ADDENDUM NO. 1

PROJECT NO: 1110169

TITLE OF PROJECT: Visitor Center Repairs and HQ Restroom Replacement

FACILITY LOCATION: Monahans Sandhills State Park

C-07

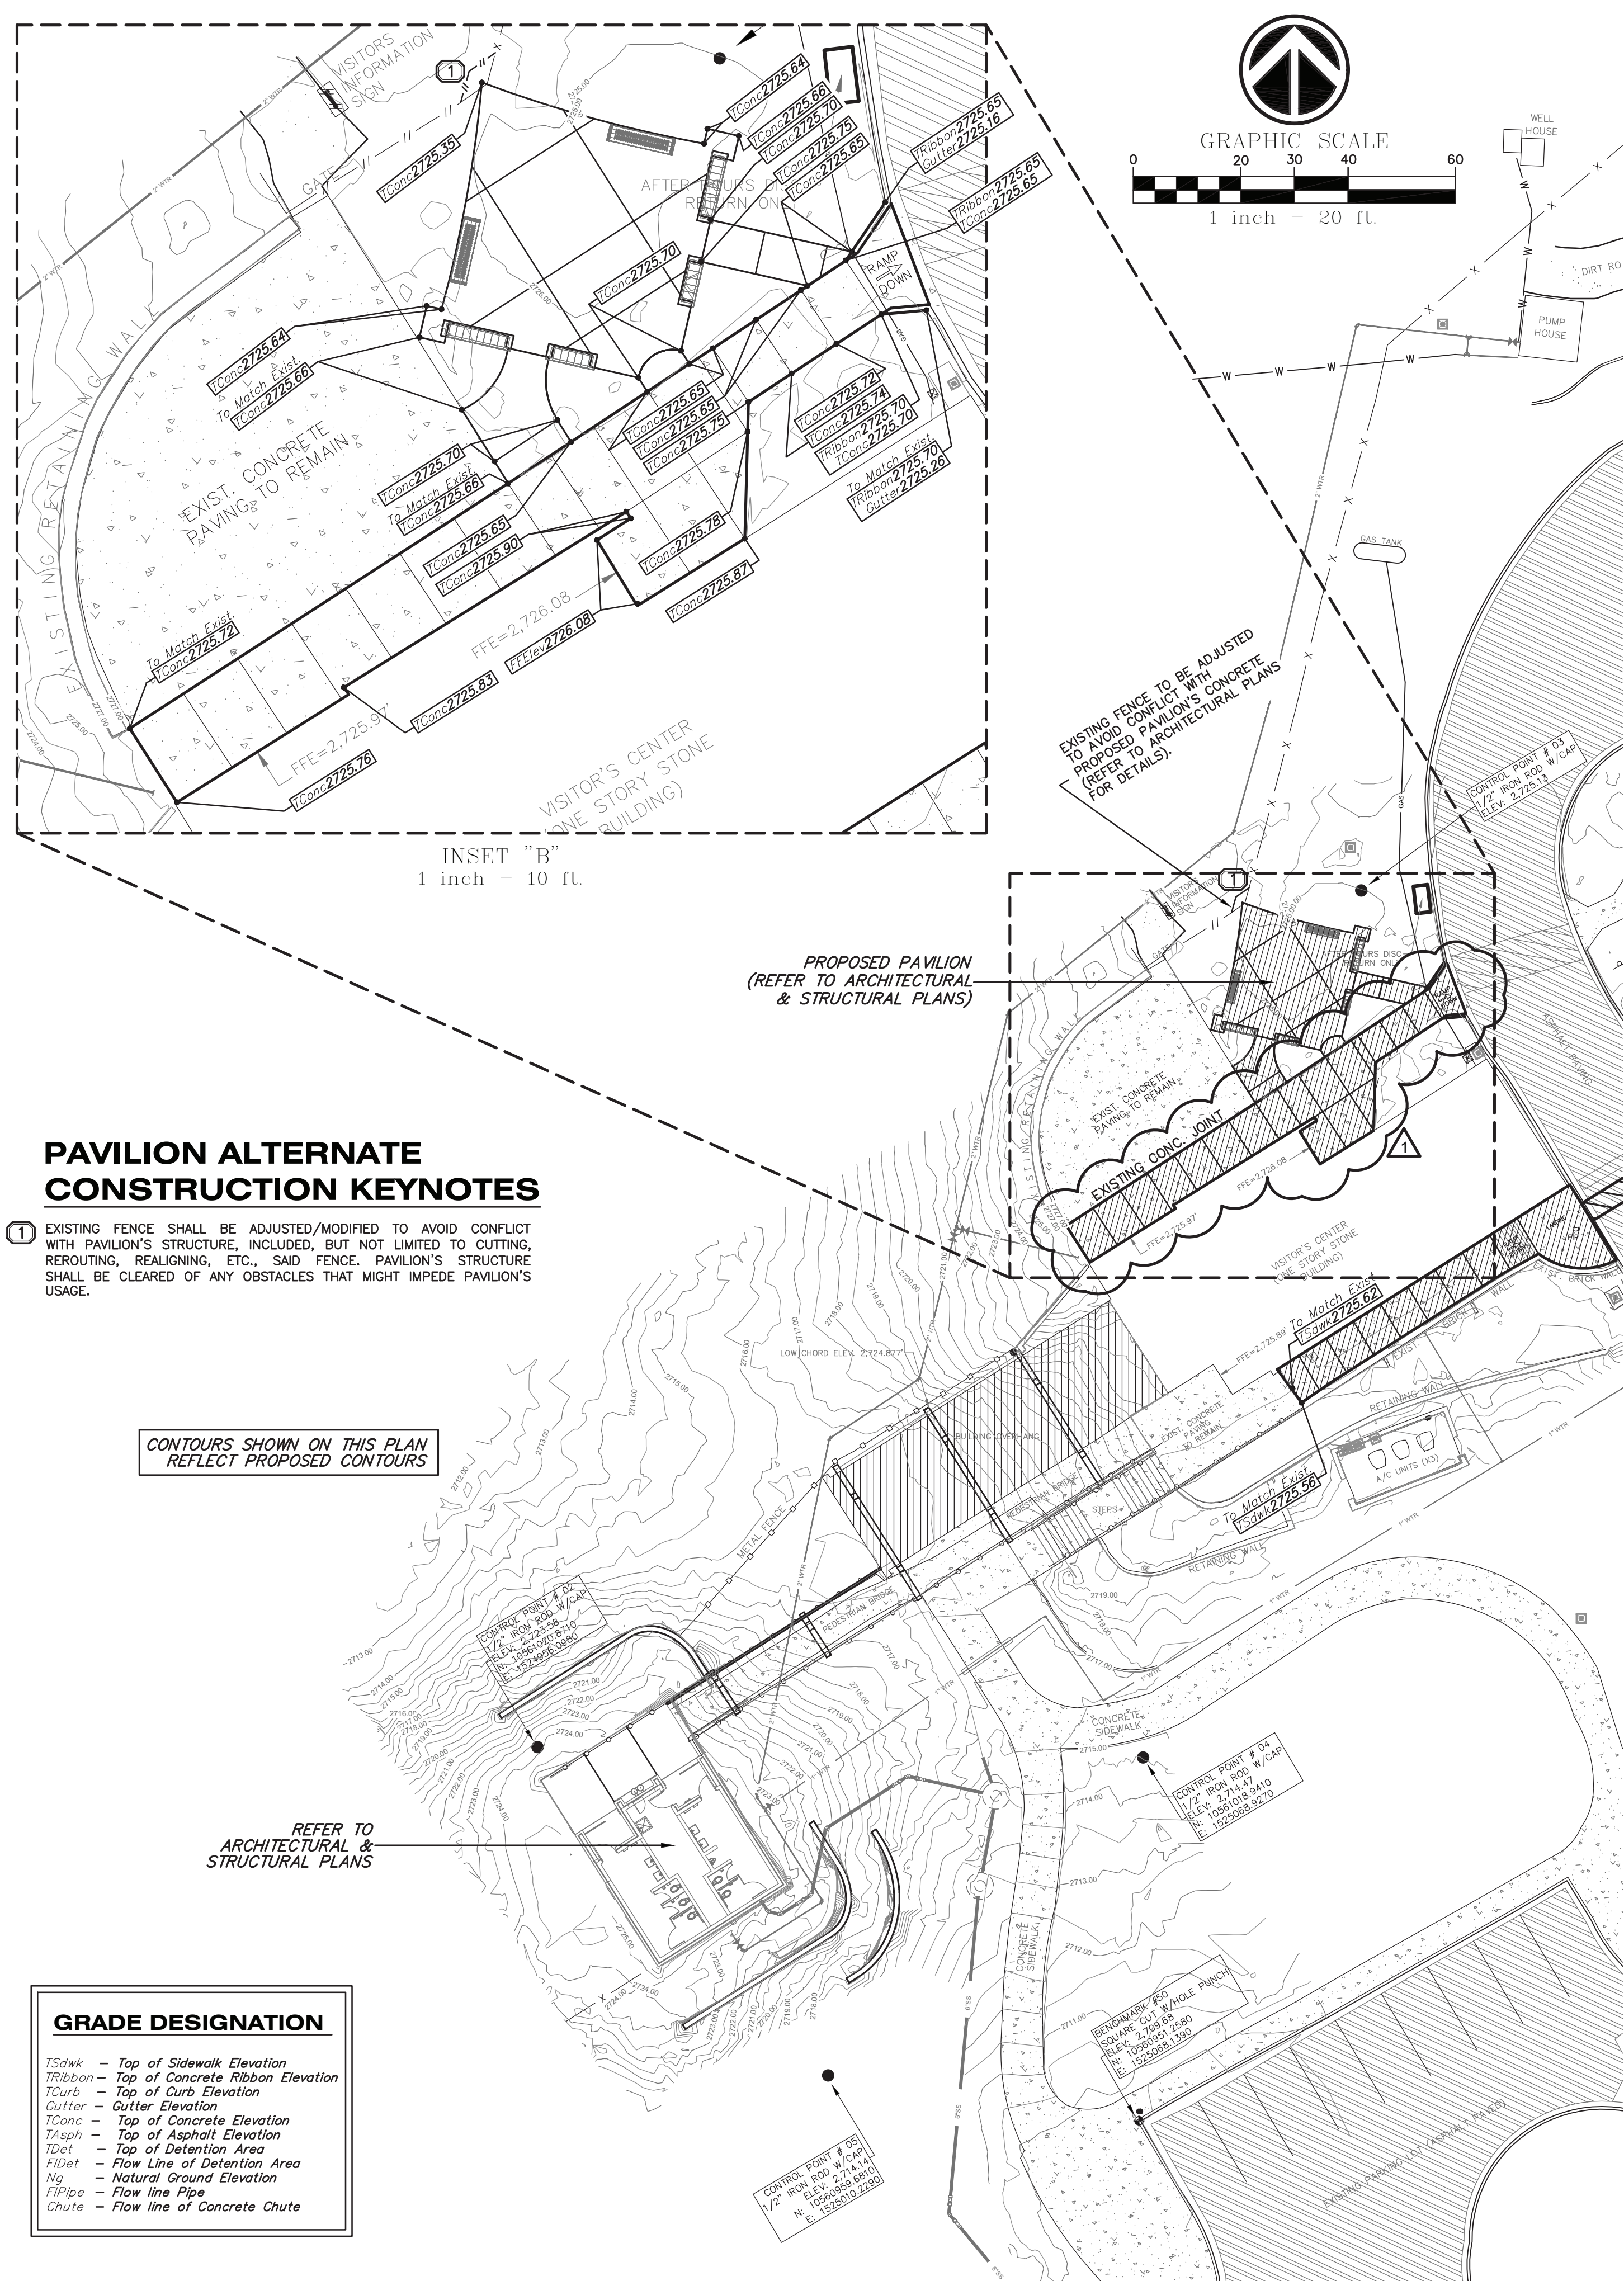
REVISED:
ADD1 5/07/21
SIDEWALK WAS STRAIGHTENED, GRADES REVISED TO MEET A.D.A. REQ.

PARKING SPACES RE-ARRANGED, A.D.A. SIGN ADDED.

SHEET NUMBER
 C-09

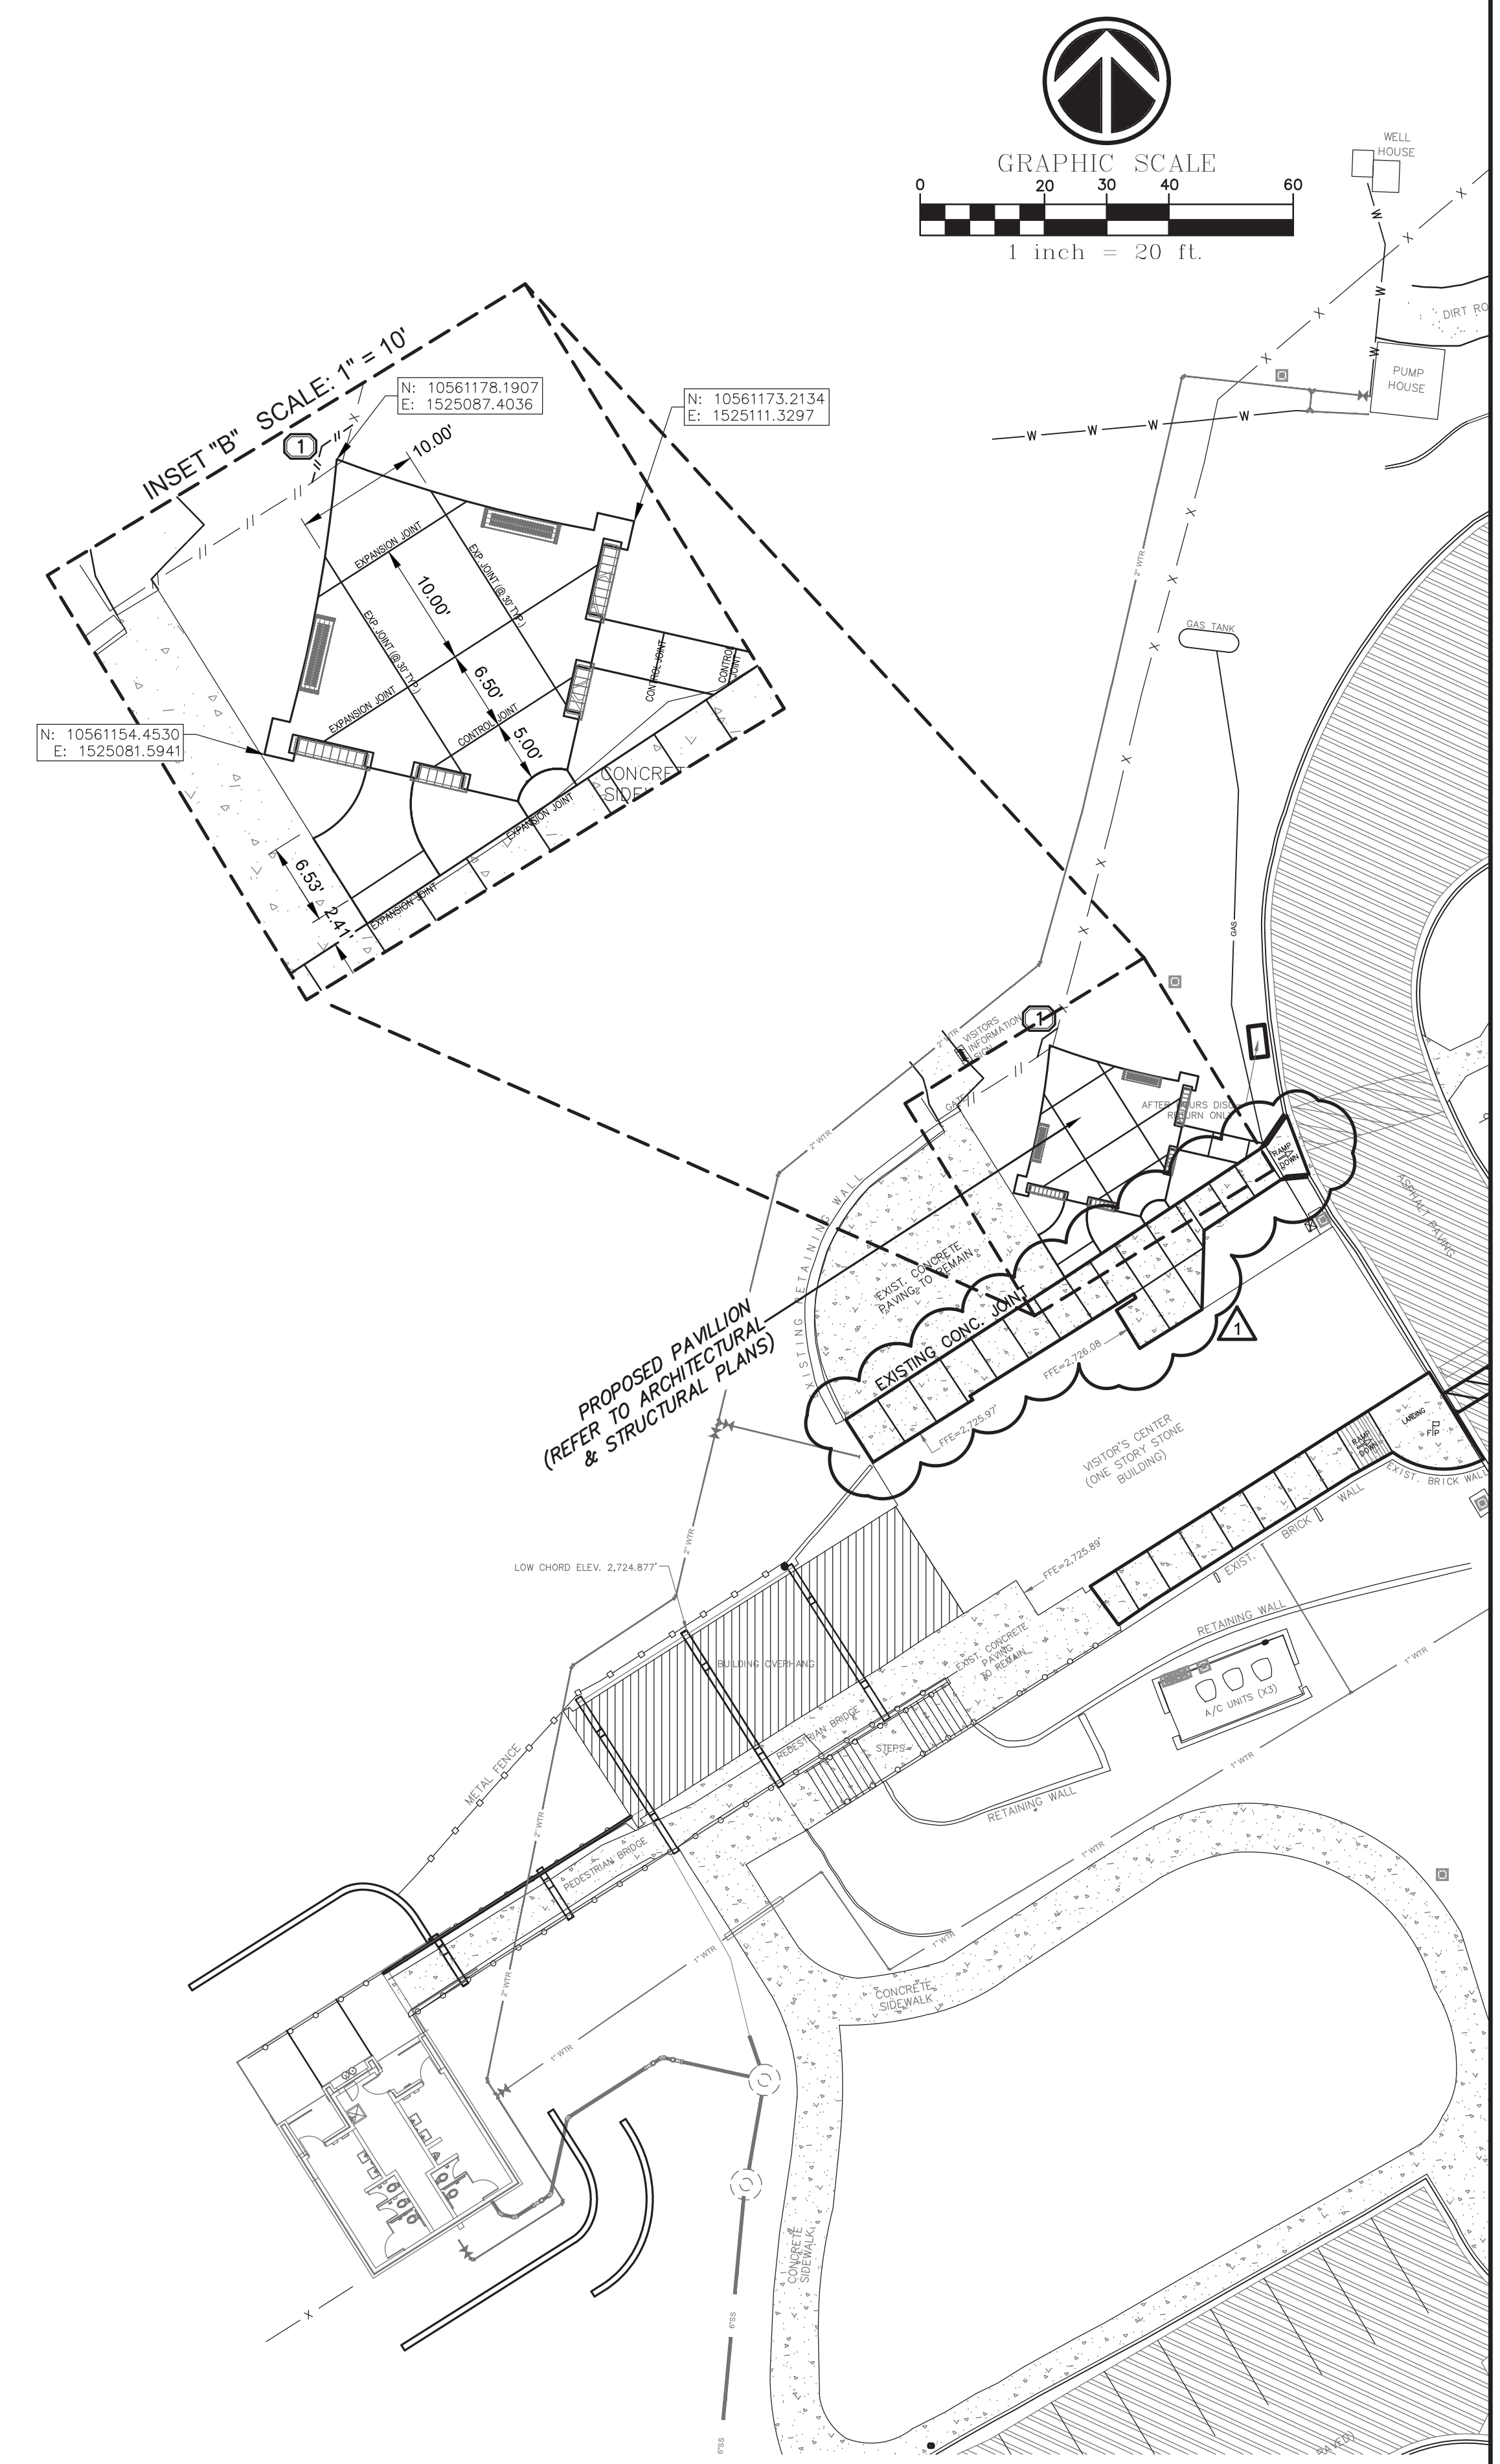
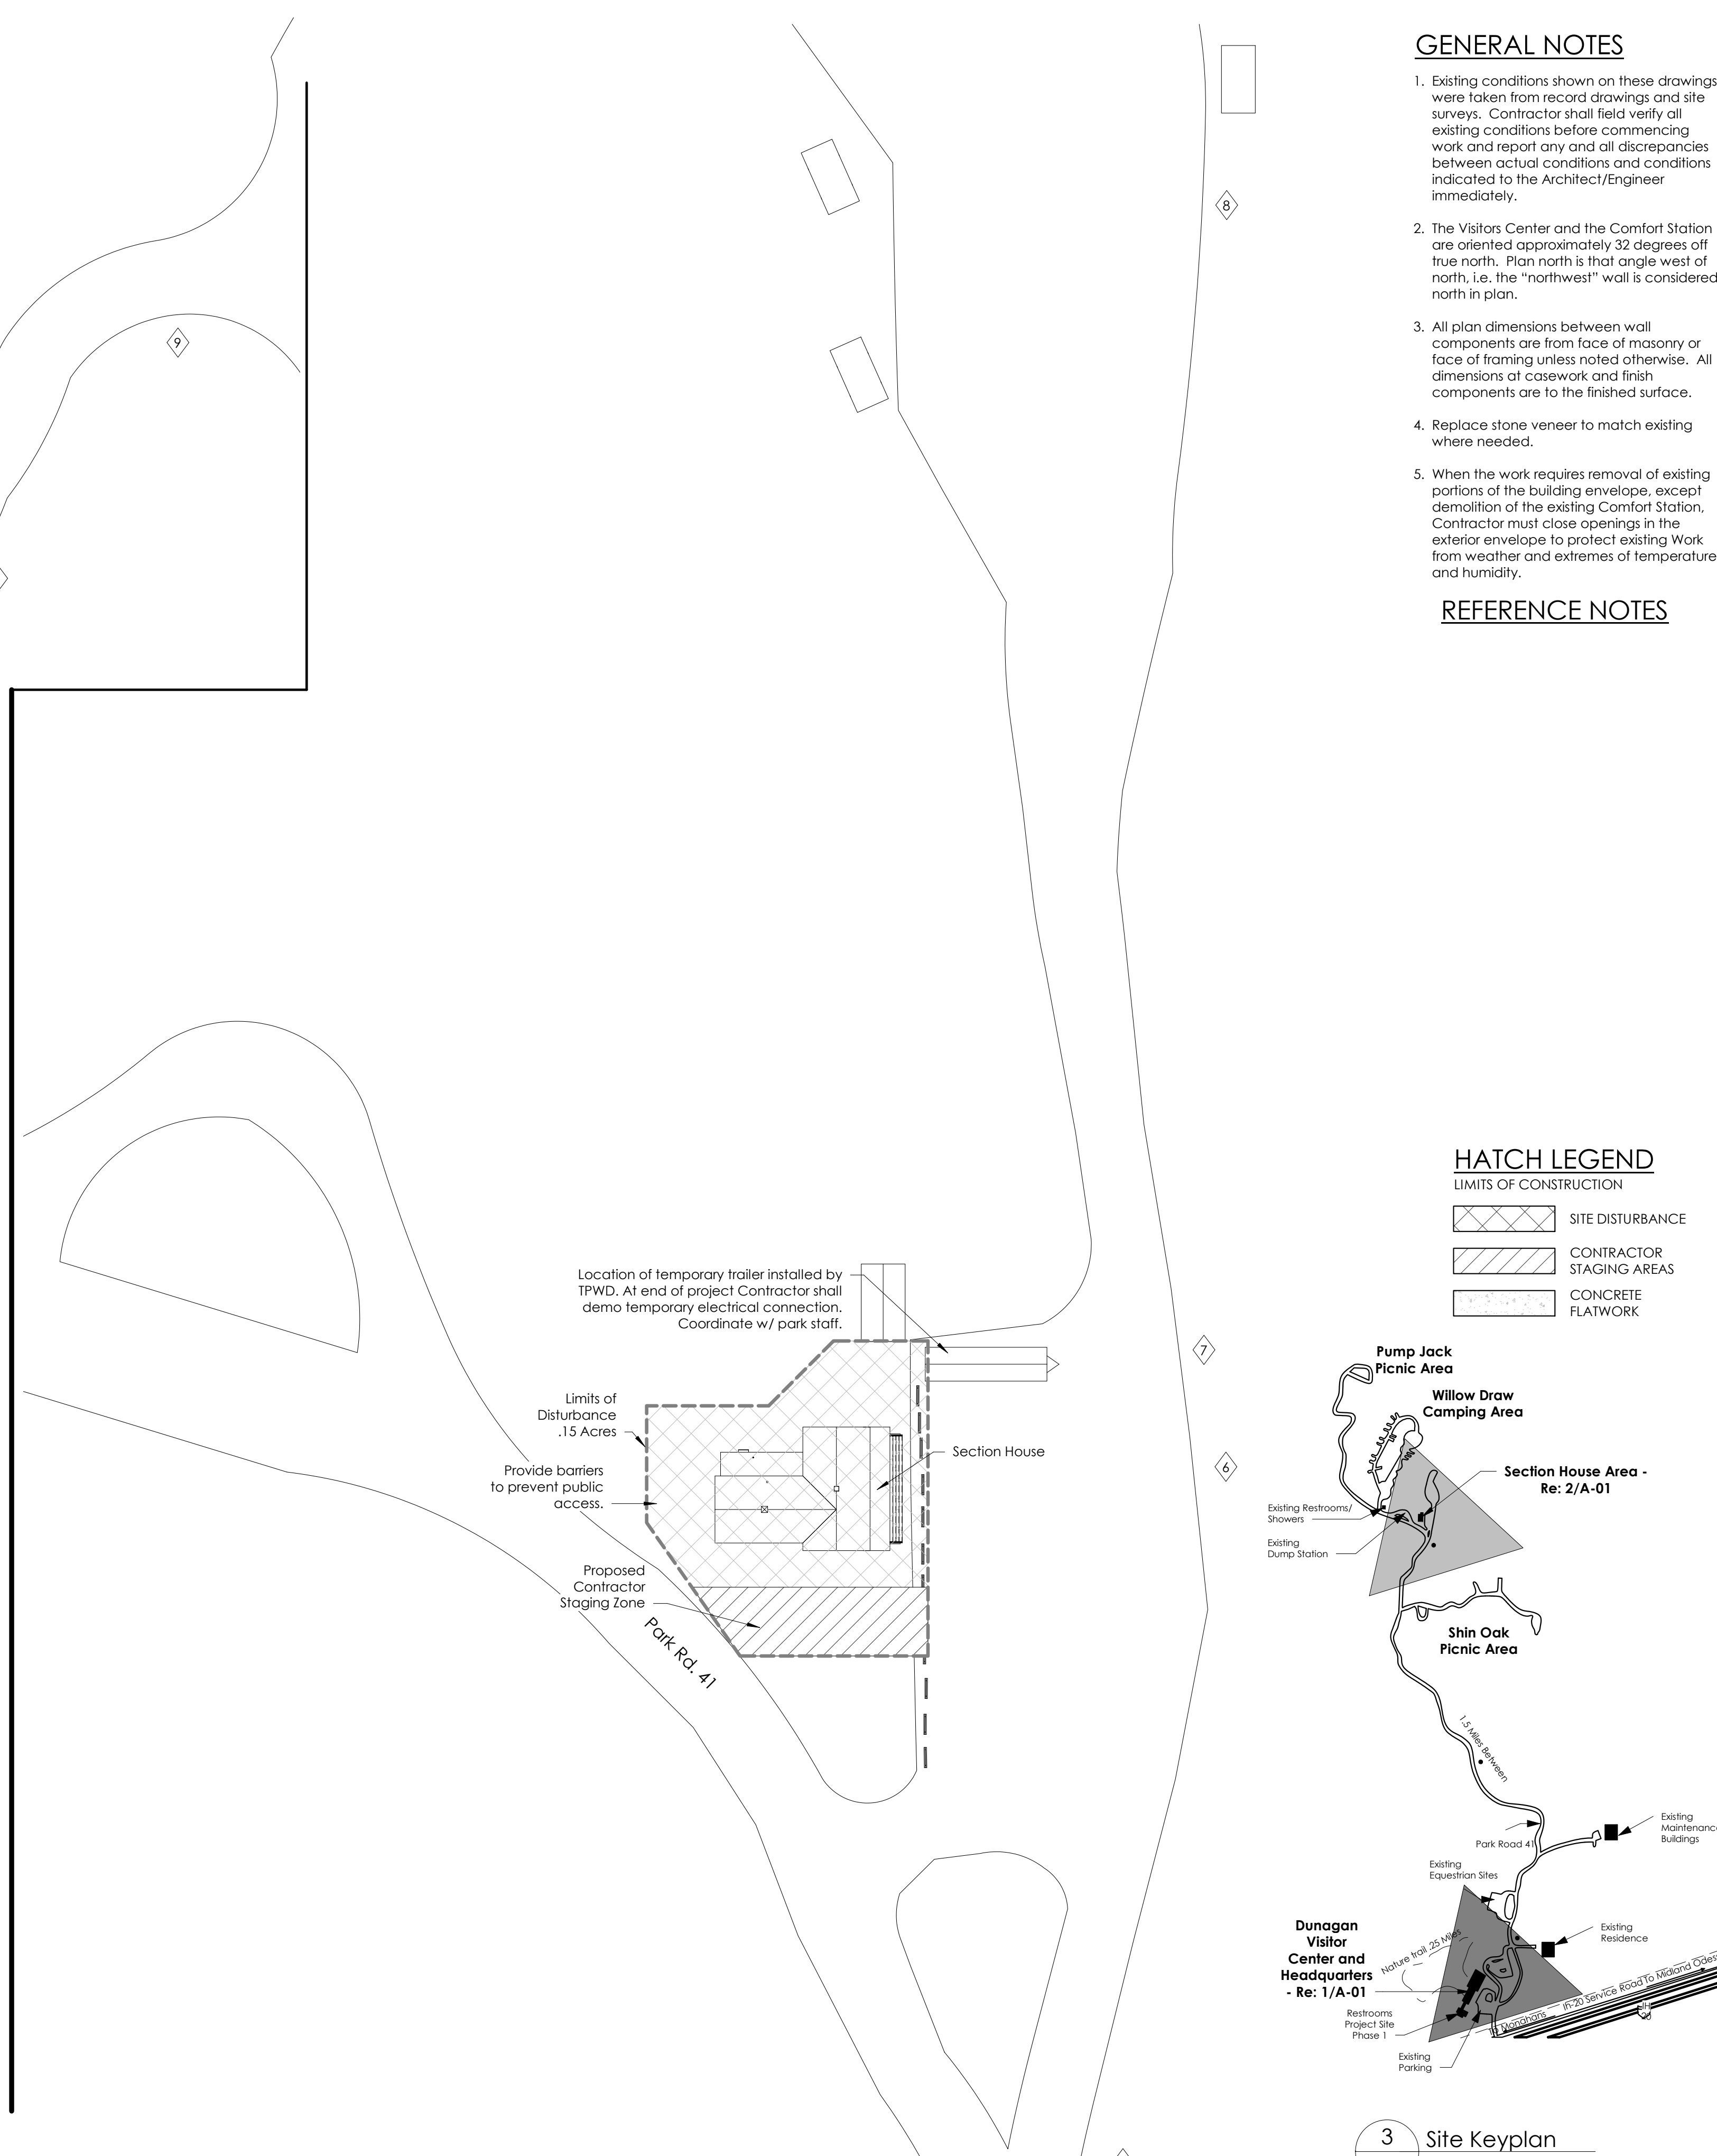
DATE: 03/19/2021
 DESIGNED BY: J.D.Z.
 DRAWN BY: J.D.Z.
 REVIEWED BY: C.C.
 REVISED:
 ADD 1 5/07/21
 SIDEWALK WAS STRAIGHTEN GRADES REVISED TO MEET ADA REQ.
